SERVICE BULLETIN

M-1003

1991 MODEL CHANGES

The purpose of this Service Bulletin is to alert Dealers to several changes that Harley-Davidson has made since the beginning of 1991 vehicle production. This Service Bulletin has three parts.

Figure 1. Spark Plug

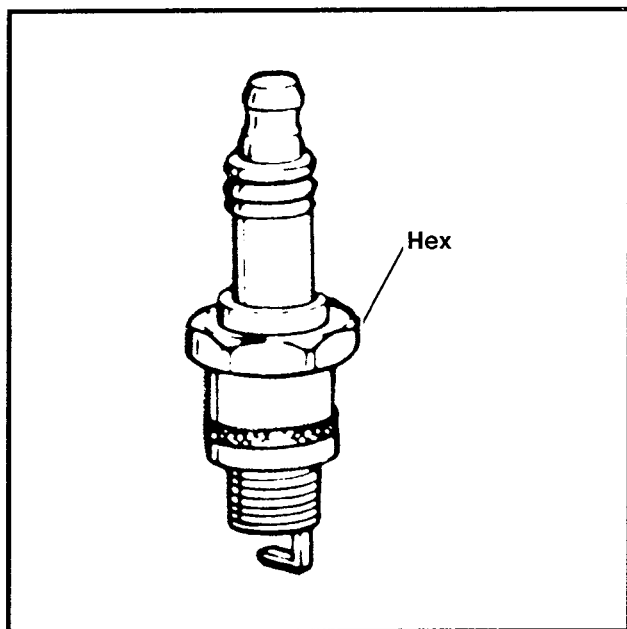
Champion Spark Plugs, Inc. has stopped making the 32317-86 XLH spark plug and is manufacturing a new plug. The new spark plug, Part No. 32317-86A for XLH motorcycles, has the same operating characteristics as the previous spark plug, but the hex size has changed. Instead of the 11/16 in. hex it now has a 5/8 in. hex.

Figure 3. Circuit breakers and Connections - Before

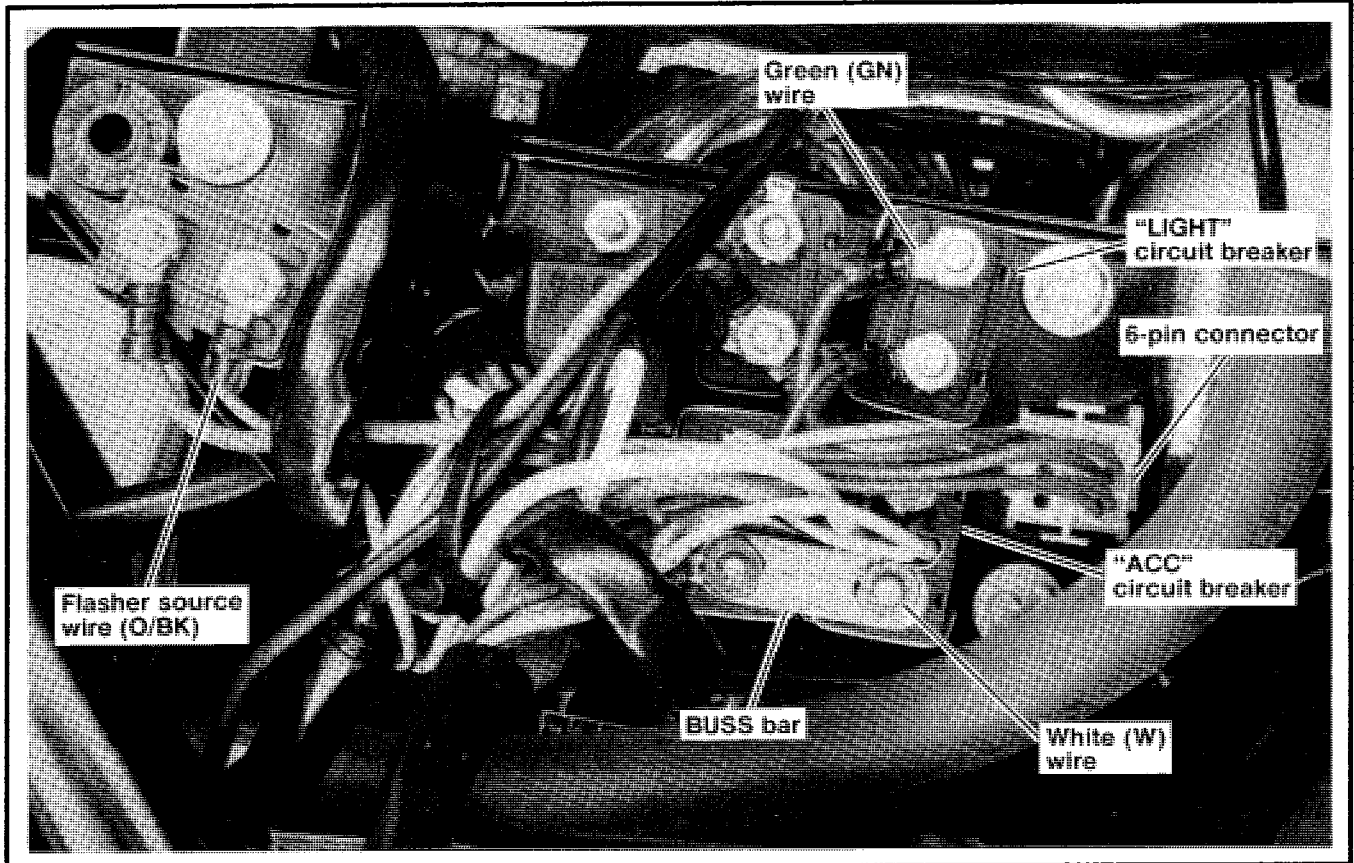
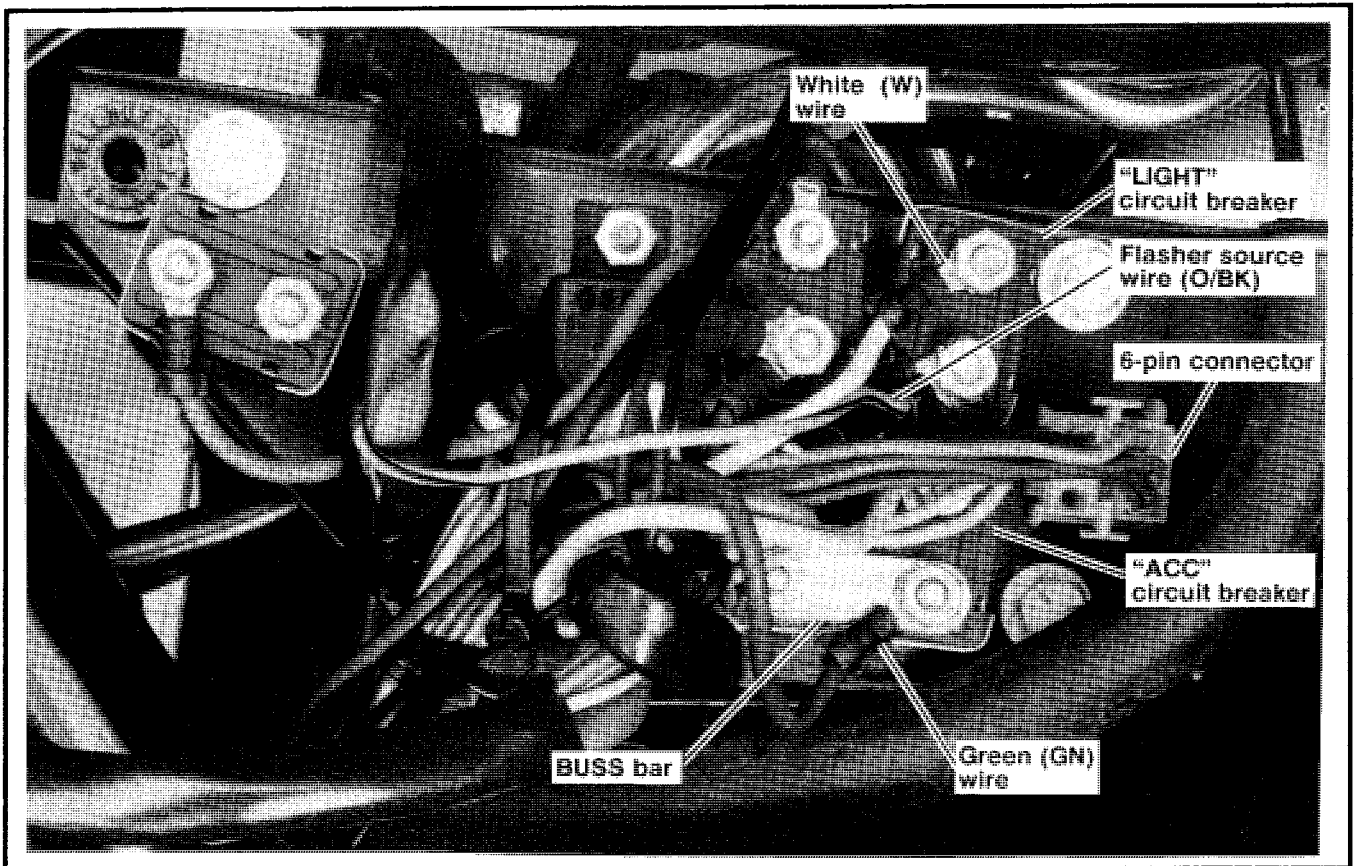
The 4-way flasher on FXRP Police motorcycles, as currently wired, drains the battery. This part of the Service Bulletin tells dealers how to rewire the 4-way flasher on FXRP Police motorcycles. Rewiring the 4-way flasher as described below will eliminate battery drain.

1. See Figures 2 and 3. Remove the instrument panel to gain access to the back of the ignition/light switch. Remove the ignition/light switch jumper wire (W).
2. Disconnect the flasher hot wire (O/BK) at the "AUX" circuit breaker.

5. Connect the flasher hot wire (O/BK) to the "ACC" circuit breaker with the orange wires.
6. Connect the green (GN) wire to either copper terminal at the BUSS bar.
7. Connect the white wire (W) to the "LIGHT" circuit breaker copper terminal. Connect the 6-pin connector.

Figure 5. FLT Models Wiring Schematic Detail

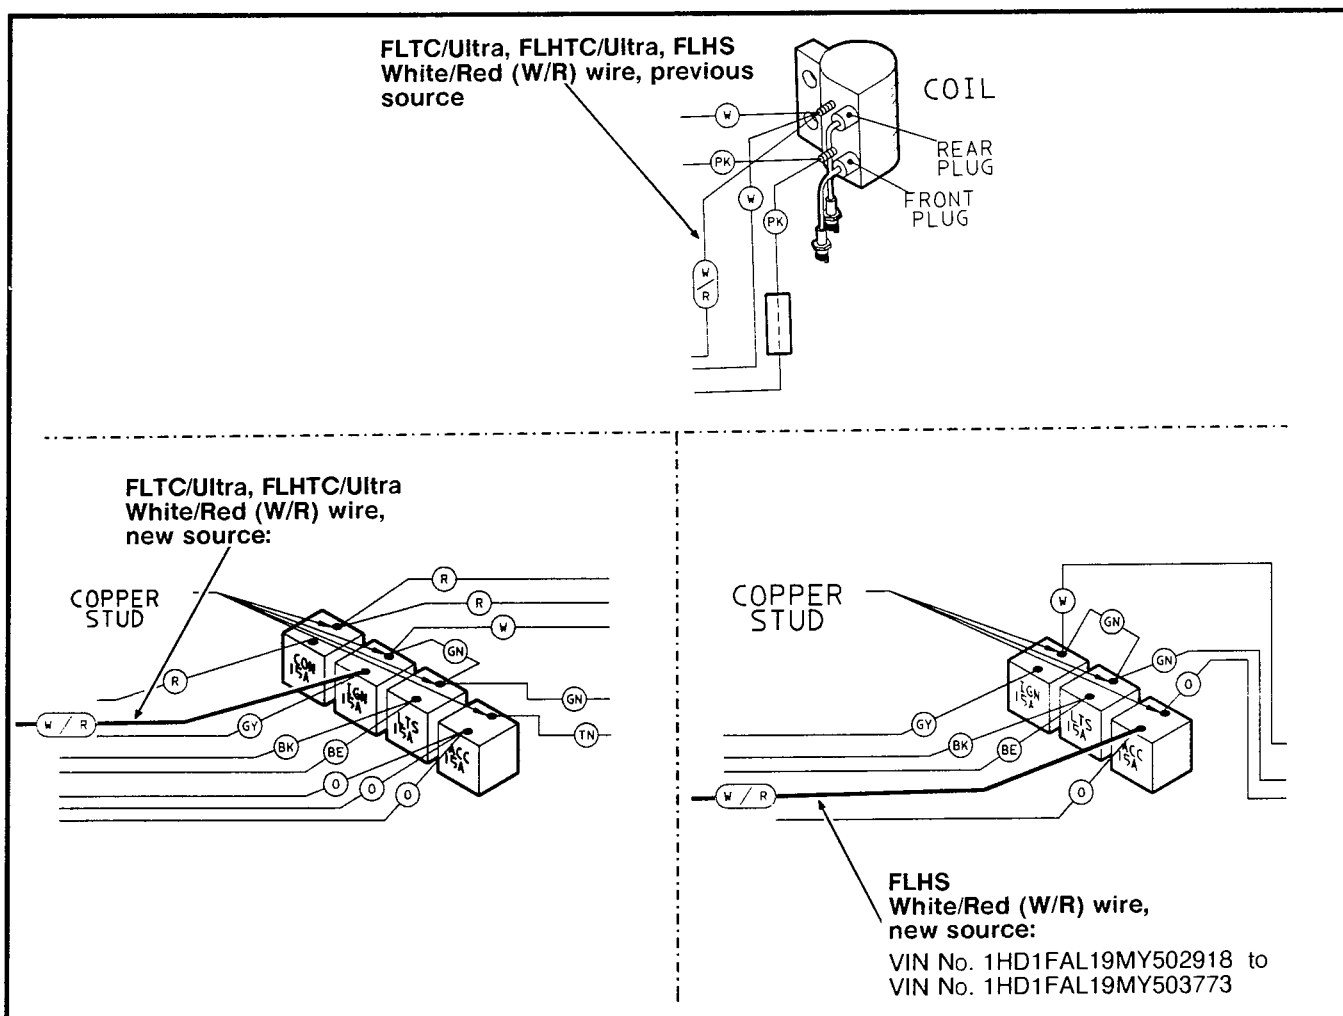
See Figure 5. FLTC/Ultra, FLHTC/Ultra – The stoplamp hot wire, White/Red (W/R) source has been moved from the ignition coil to the ignition (IGN) circuit breaker. It is connected to the silver stud with the gray (GY) wire. This change begins with VIN No. 1HD1D*L19MY502918 and continues to the present.

See Figure 5. FLHS – The stoplamp hot wire, White/Red (W/R) source was moved from the ignition coil to the accessory (ACC) circuit breaker. It was connected to the silver stud with the orange (O) wire. This change begins with VIN No. 1HD1FAL19MY502918 and ends with VIN No. 1HD1FAL19MY503773.

Beginning with VIN No. 1HD1FAL19MY503774 and continuing to the present, the FLHS model motorcycles' wiring harness has been changed to the 1990 version. This version does not have the White/Red (W/R) stoplamp hot wire. See the 1986 to 1990 Wiring Diagram book.
